SAFETY RECALL BULLETIN

SUBJECT:		No:	SR-09-005
SRS FRONT IMPACT SENSORS — SAFETY RECALL CAMPAIGN		DATE:	November, 2009
		MODEL:	See below
CIRCULATE TO:	<input type="checkbox"/> GENERAL MANAGER	<input checked="" type="checkbox"/> PARTS MANAGER	<input checked="" type="checkbox"/> TECHNICIAN
<input checked="" type="checkbox"/> SERVICE ADVISOR	<input checked="" type="checkbox"/> SERVICE MANAGER	<input checked="" type="checkbox"/> WARRANTY PROCESSOR	<input type="checkbox"/> SALES MANAGER

Header Section: 2008-09 Lancer, Lancer Evolution, Lancer Ralliart and Lancer Sportback & Lancer Sportback Ralliart Front Impact Sensor Kit

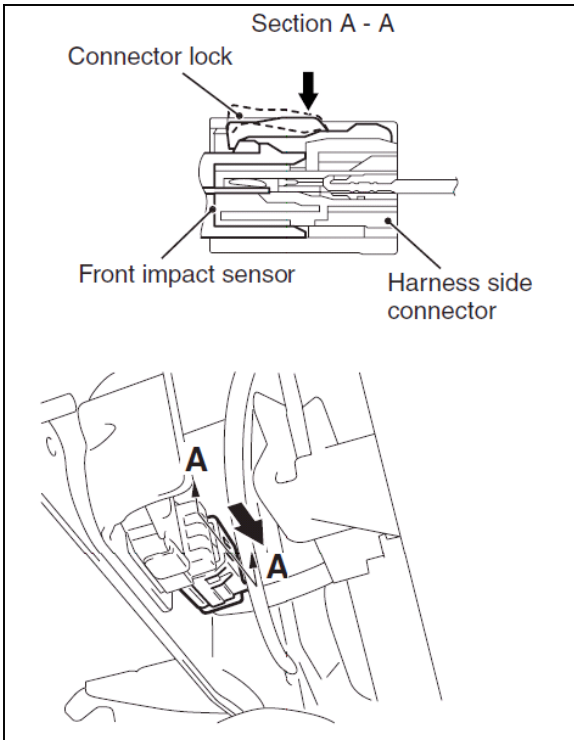
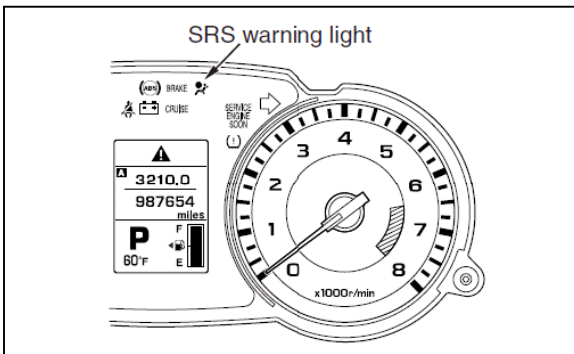
7. Remove the front impact sensor, bracket, and flange nut.
8. Install the new parts provided in the repair kit :

The new bracket and flange nut are a new design. DO NOT re-use the old bracket or nut.

- a. Securely connect the new front impact sensor to the connector.
- b. Assemble the new sensor and new bracket together, and install them with the new flange nut. Torque the nut to 12 ± 1 Nm (8 ± 1 ft/lbs).
